STAFF REPORT

Case No.: 18-SP-36

Request: Conduct a public hearing and consider a request for a Detailed Site Plan and

Planning & Zoning Commission Meeting: September 9, 2019

Special Exception #1: Chapter 2. D: Street Types

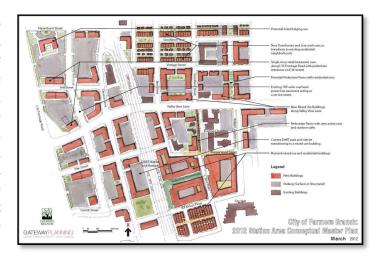
PD-86 requires a 6-foot wide sidewalk and allows 7-foot wide on-street parking. However, staff has requested the applicant to provide 8-foot wide on-street parking as that is the city-wide and industry standard and from a functional perspective, and is required to not impede traffic flow for an 11-foot wide travel lane. To meet the 8-foot wide on-street parking request, the applicant has proposed a 5-foot wide sidewalk and requested a Special Exception.

Staff supports Special Exception # 1
